**SOUTHERN NEVADA AMENDMENTS
TO THE
2024 INTERNATIONAL BUILDING CODE
(CLARK COUNTY AMENDED)**

Adopted by action of the Clark County Commission on July 15, 2025 for correlation with the 2024 International Building Code. This document and the 2024 International Building Code shall be effective on January 11, 2026.

**FIGURE 1110.4.5.3
SIZE AND MANEUVERING CLEARANCES AT THE ADULT CHANGING SURFACE**

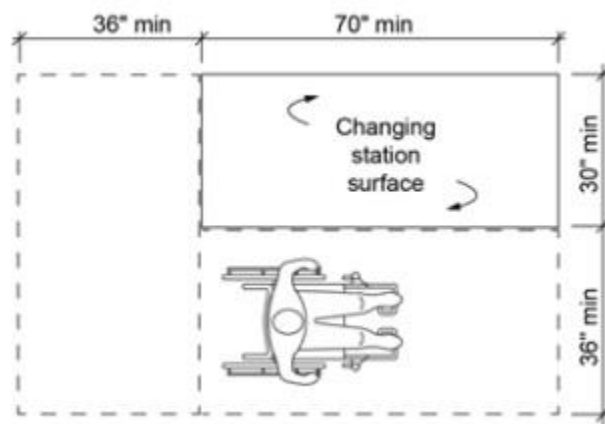
Add new Section 1110.4.5 as follows:

1110.4.5.3 Changing surface. A changing surface shall be provided and shall comply with Section 1110.4.5.3.

1110.4.5.3.1 Size. The changing surface shall be 70 inches (1778 mm) minimum in length and 30 inches (762 mm) minimum in width.
